ADDENDUM No. 1

Project Name:	Owner: Charter Township of Canton Project Name: Canton Public Safety Building Renovations	**Addendum No:** One (1)
Project Number:	21-130	Issue Date: March 18, 2022
Project Location:	1150 South Canton Center Road, Canton Twp, MI 48188

This Addendum consists of (3) typed pages and the following (19) attachments:

SHEET NO.
A0-08

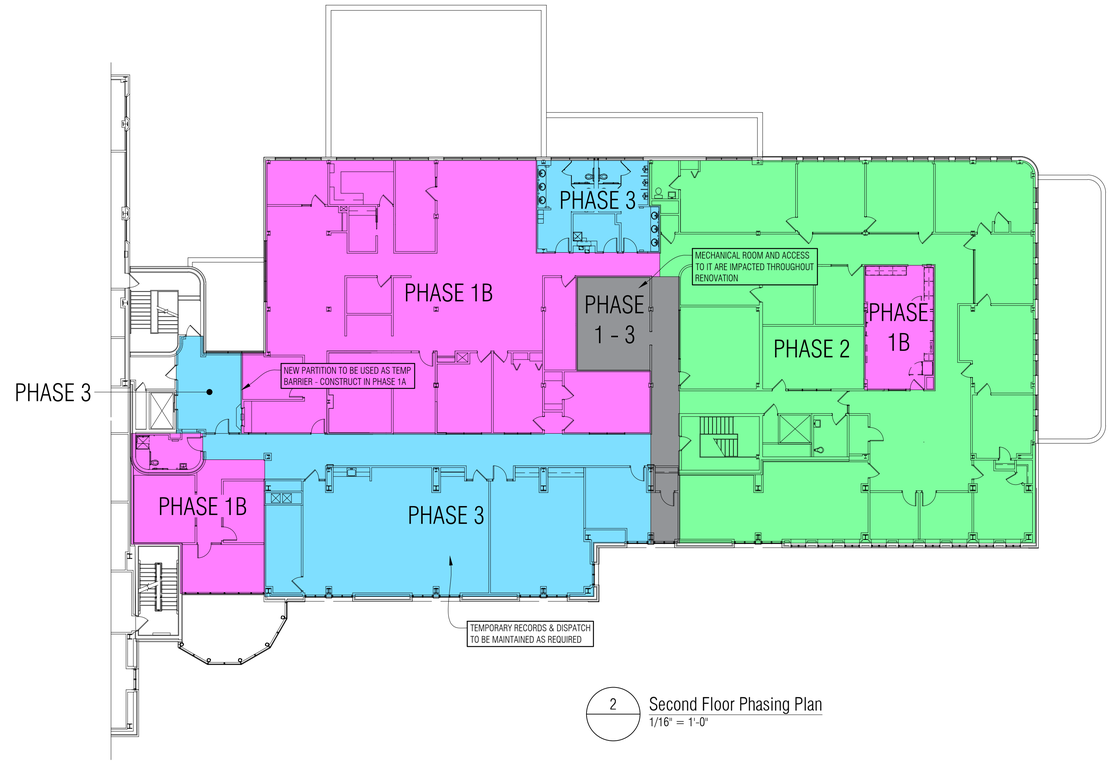
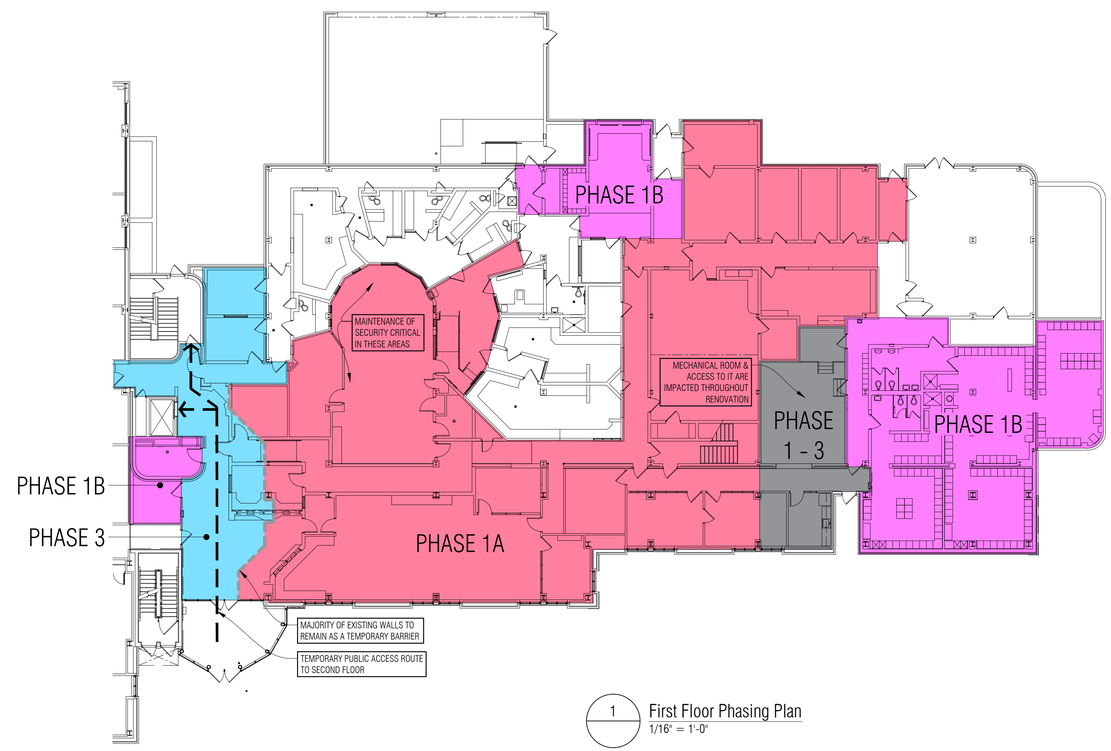
ITEM A2 A0-08 Phasing Plan (Issued)
A. Proposed Construction Phasing and Sequence of Construction Diagrams for the first and second floors.

SHEET NO.
A1-01

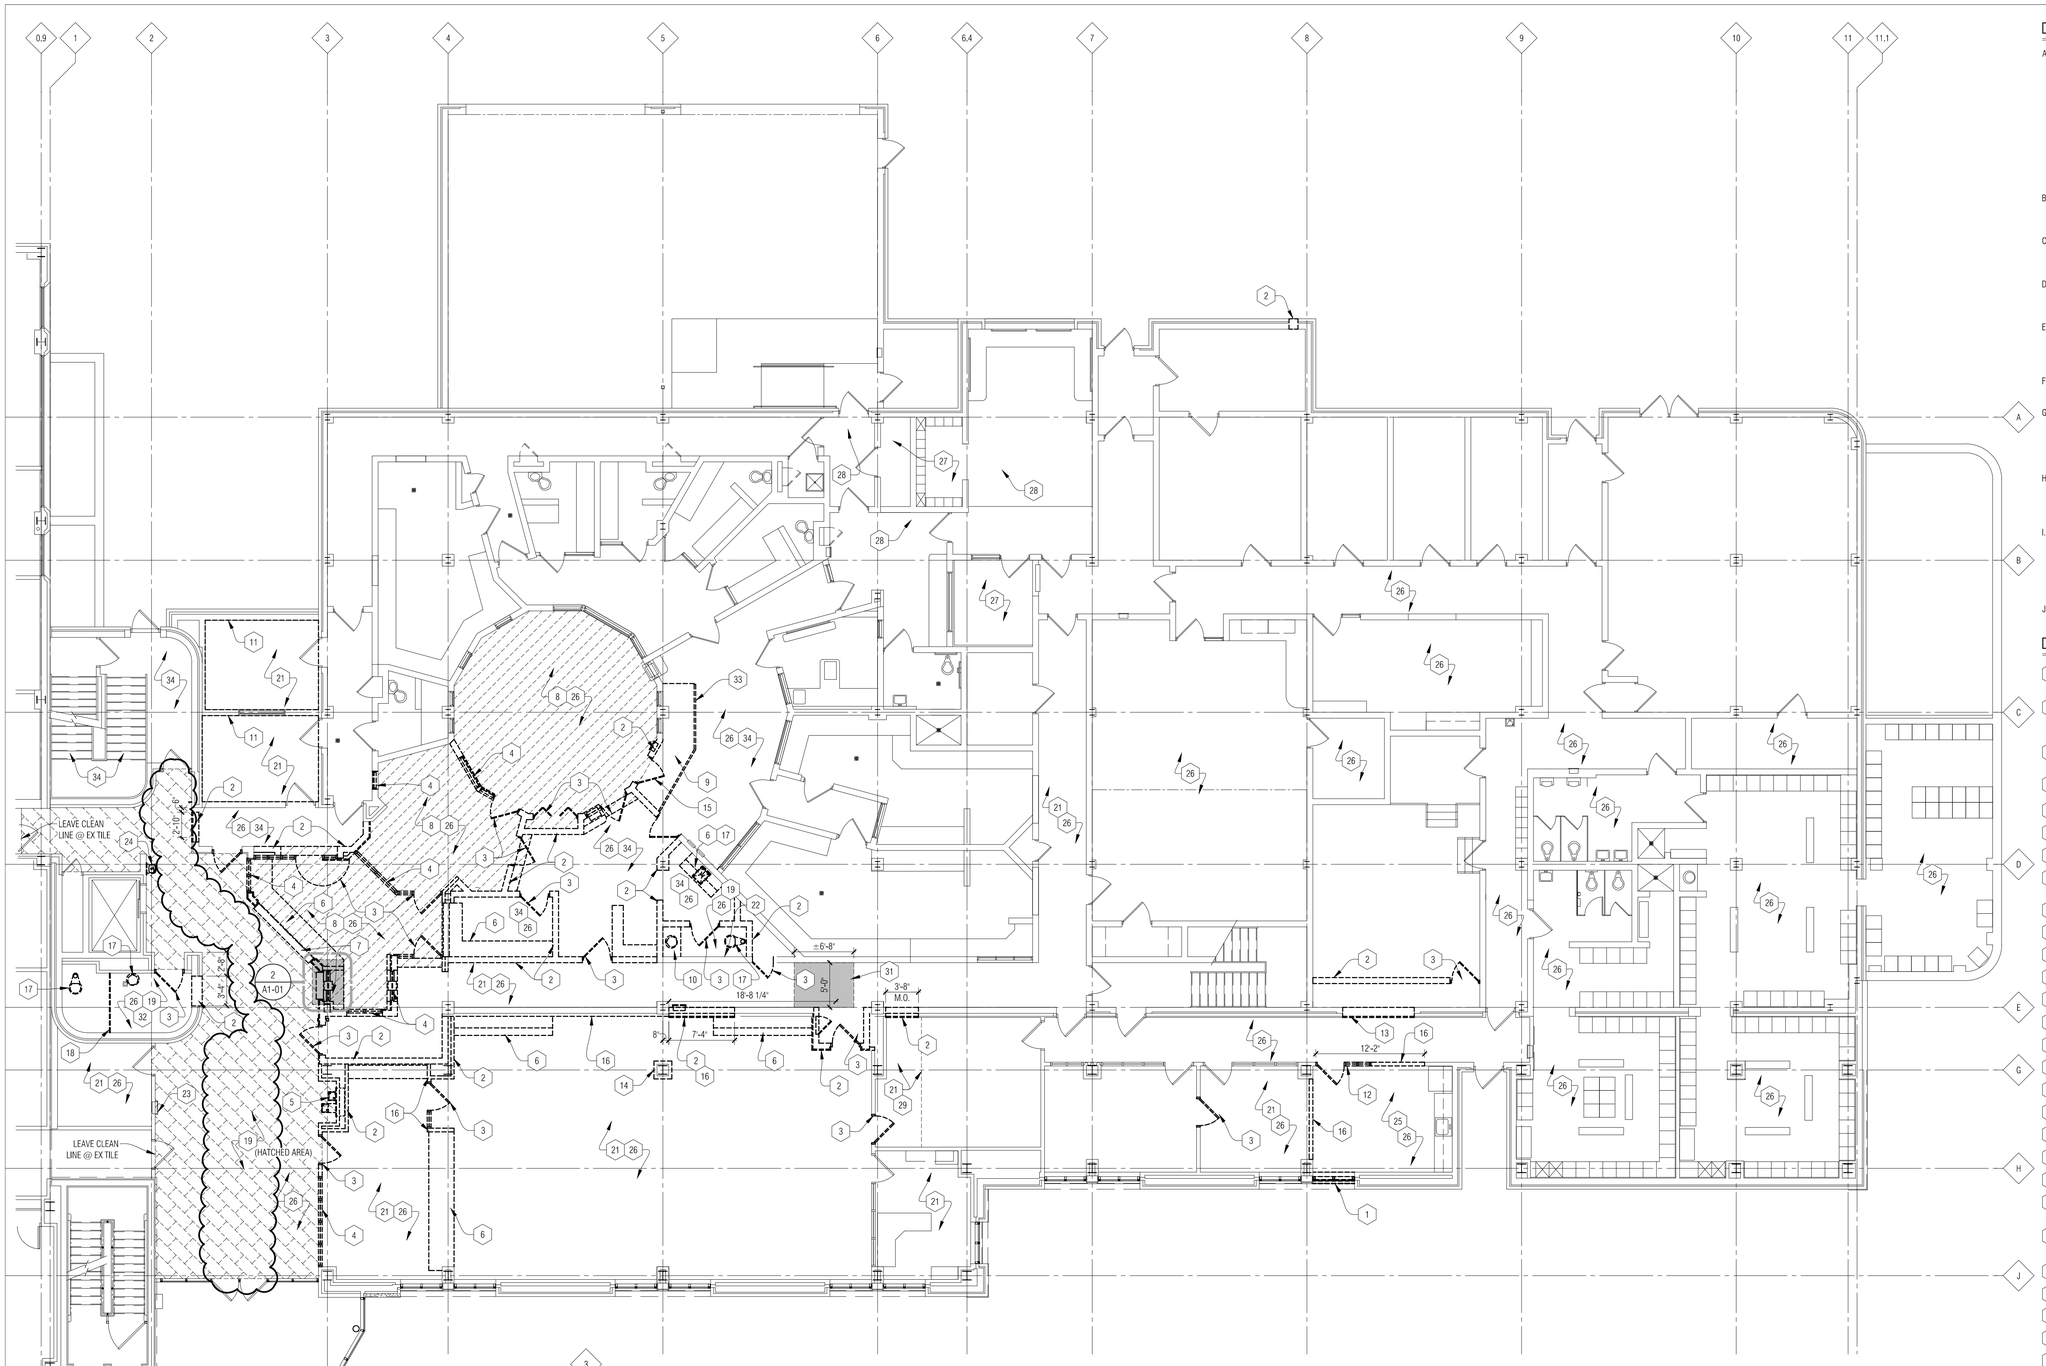
ITEM A3 A1-01 Demolition First Floor Plan (Revised but Not Re-Issued)
A. Eliminated keynote No. 35 regarding the temporary access enclosure in the existing lobby and removed the dashed lines the defined it on the plan.

PLAN DETAILS

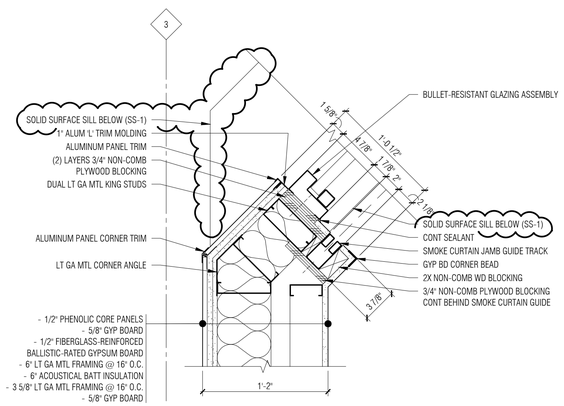
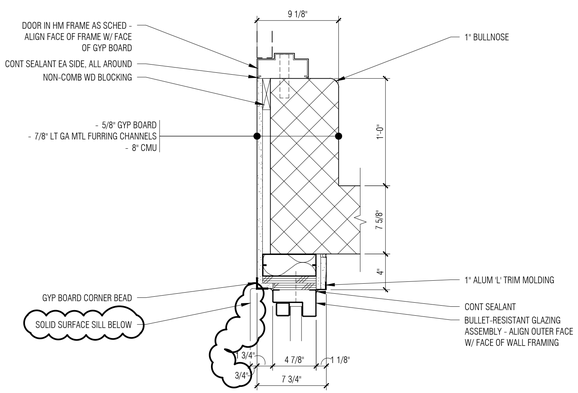
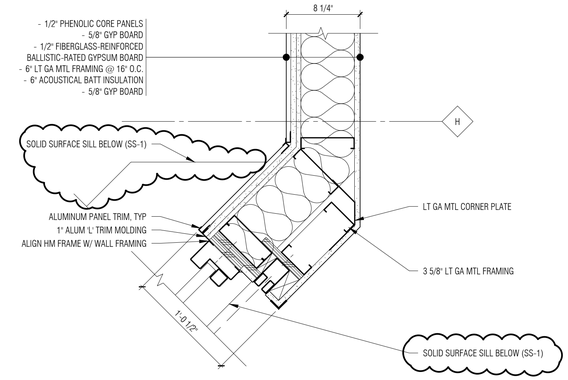
ITEM A5 A3-10 Plan Details (Revised & Re-Issued)
A. Added notes and graphics to details 2, 3 and 5 indicating solid surface sills SS-1.

SHEET NO.
A8-01

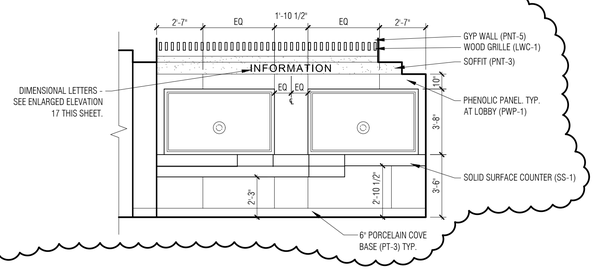
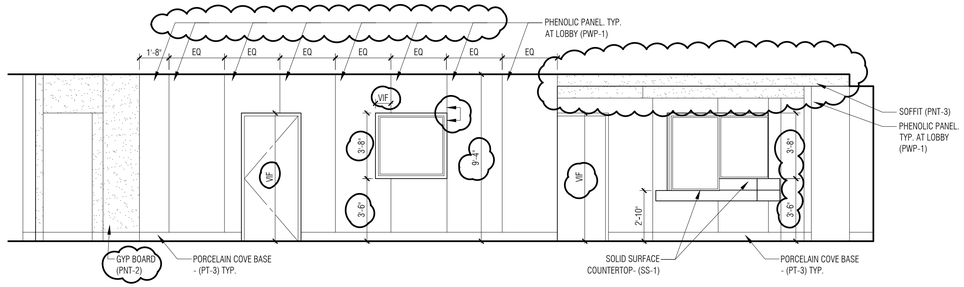
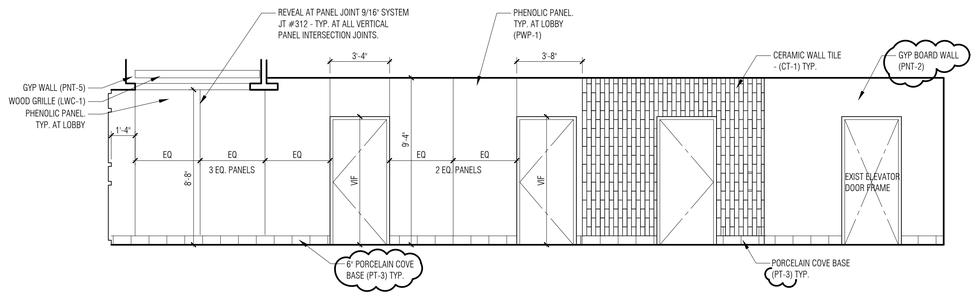
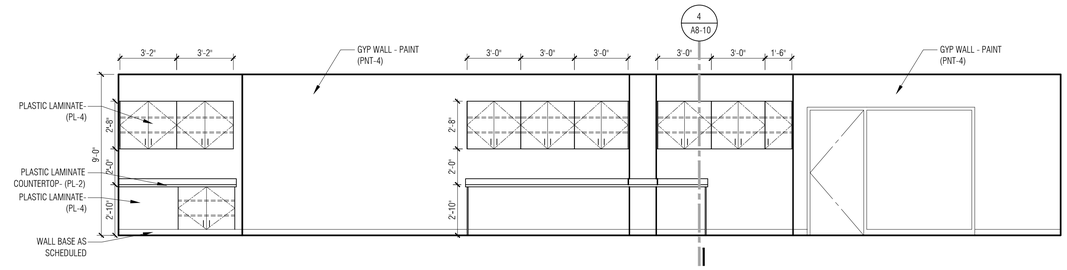
ITEM A7 A8-01 Interior Elevations (Revised & Re-Issued)
A. Added vertical dimensions for base, openings and ceiling to elevations 1, 2, 3, 4 and 6 to clarify phenolic panel heights.
B. Added notes to clarify extents of solid surface counter tops, phenolic wall panels and painted gyp bd.
C. Added ceiling soffit graphics to elevation 6.
D. Added graphics and layout for wall mounted aluminum signage in elevations 2 and 6.

SHEET NO.
A8-02

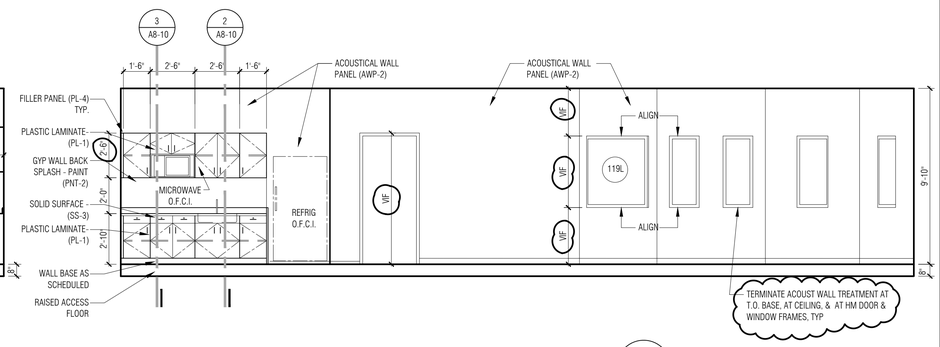
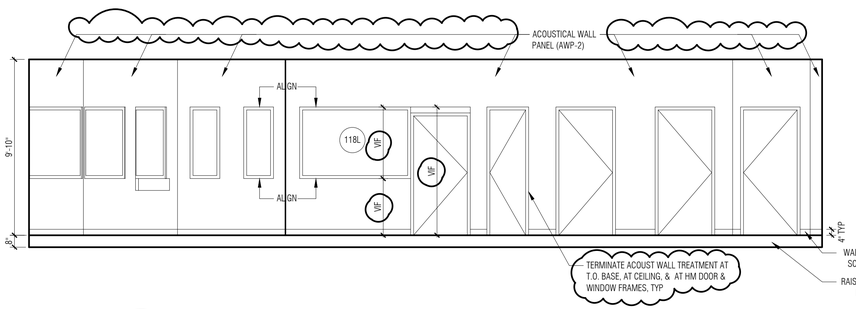
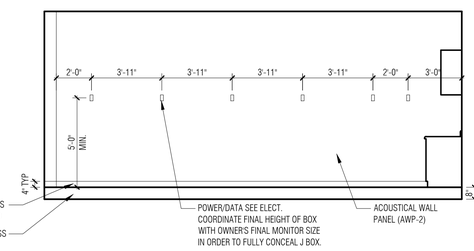
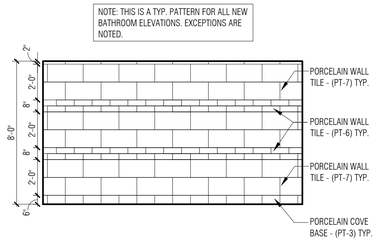
ITEM A8 A8-02 Interior Elevations (Revised & Re-Issued)
A. Added vertical dimensions for base, openings and ceiling to elevations 1, 3 and 4 to clarify acoustic panel heights.
B. Add solid surface countertops SS-3 to elevation 13 and 17 in lieu of plastic laminate PL-2.

5 Typical Vanity Section
3/4" = 1'-0"

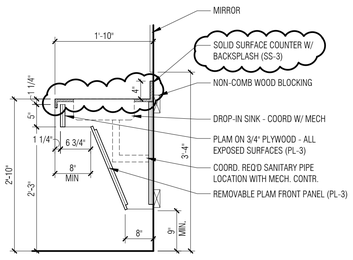
ITEM A9 A8-10 Millwork Details (Revised & Re-Issued)
A. Added solid surface lavatory counter SS-3 in lieu of plastic laminate in Typical Vanity Section Detail 5.

SHEET NO.
M5.1

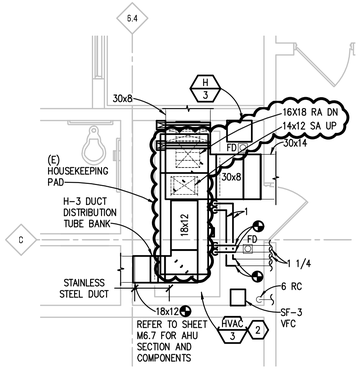
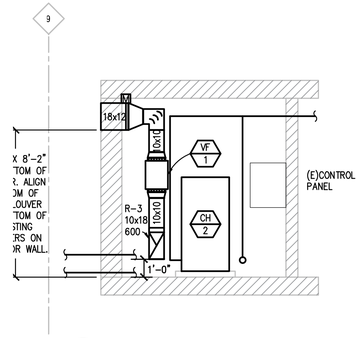
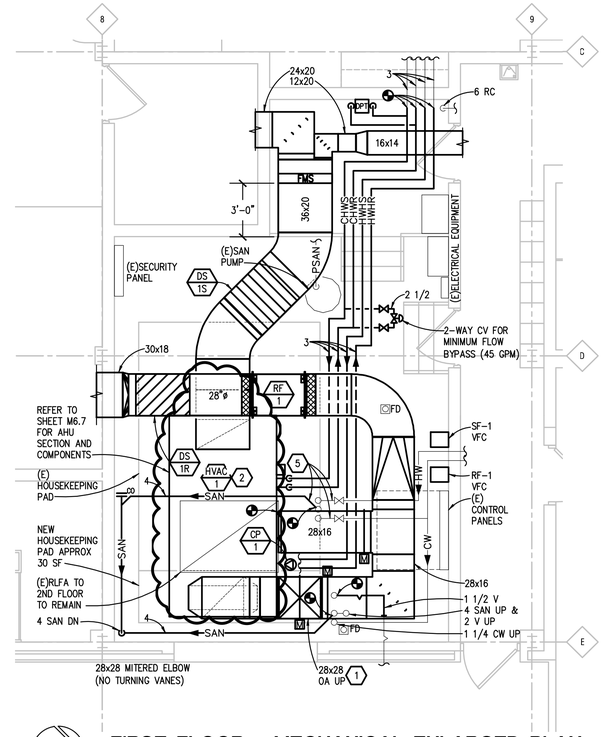
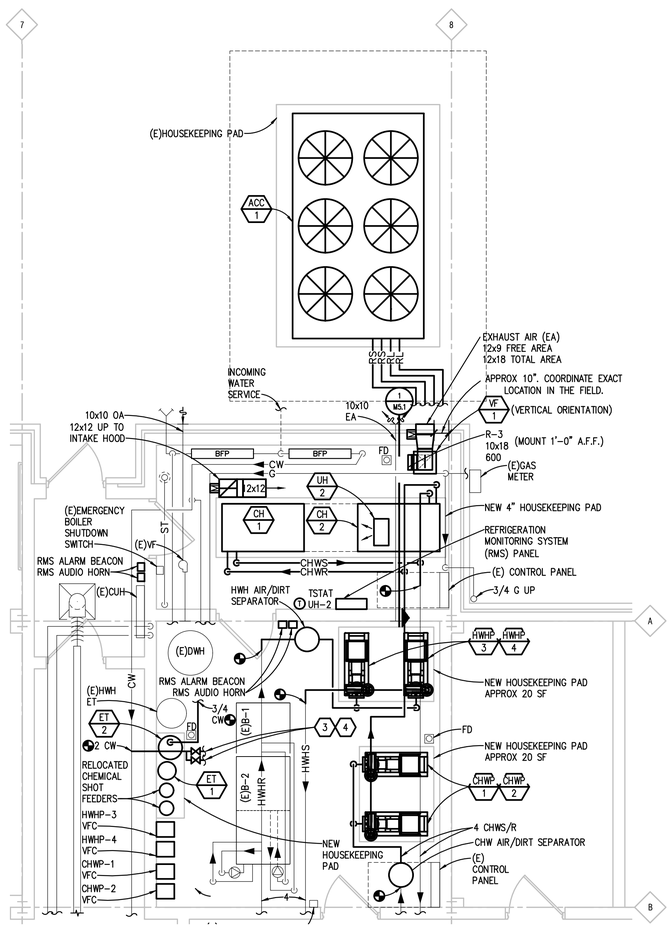
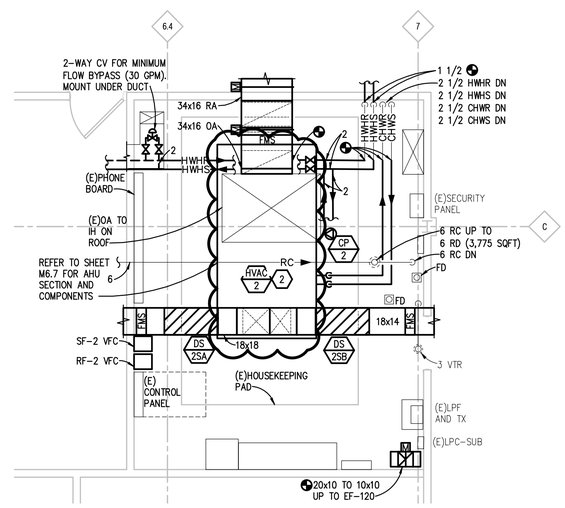
ITEM M1 M5.1 Mechanical Enlarged Plan (Revised & Re-Issued)
A. Revised equipment sizing and ductwork connections to HVAC-1, HVAC-2, and HVAC-3.

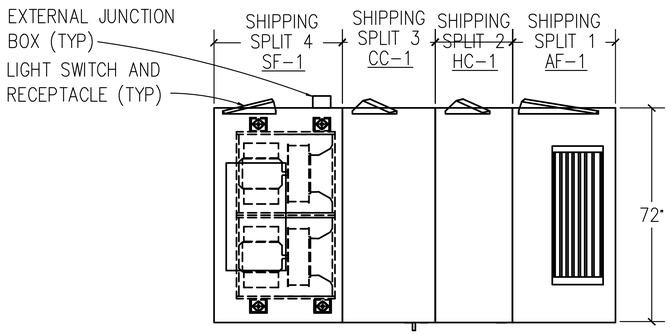
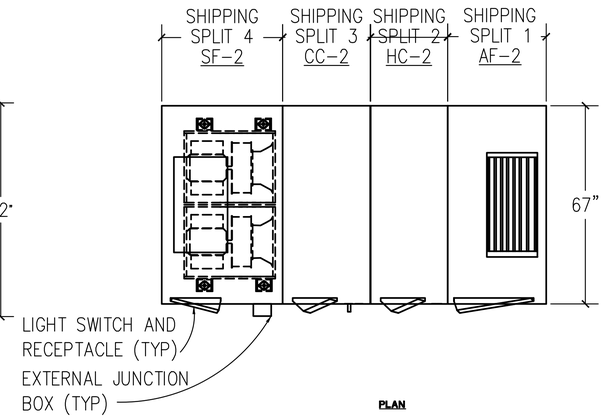
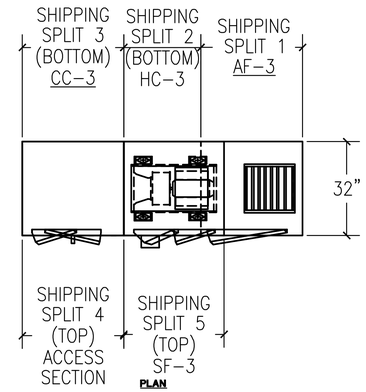
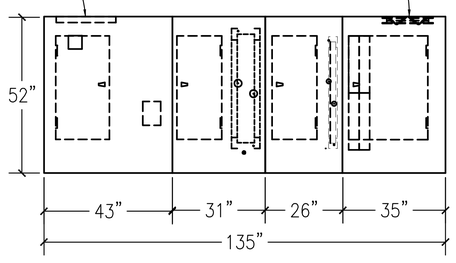
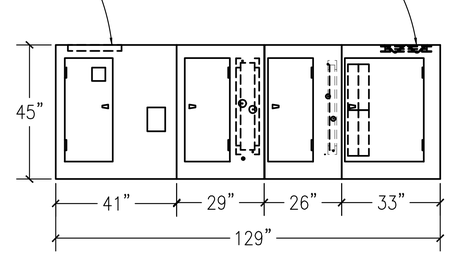
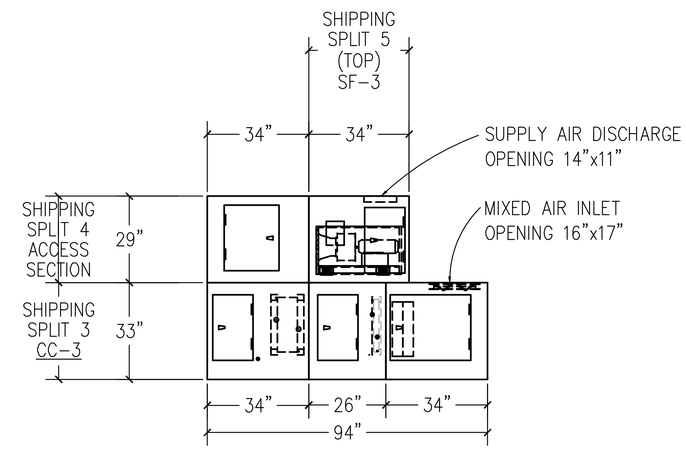
ITEM M2 M6.7 AHU Details (Revised & Re-Issued)
A. Revised equipment section and plan views for HVAC-1, HVAC-2, and HVAC-3.
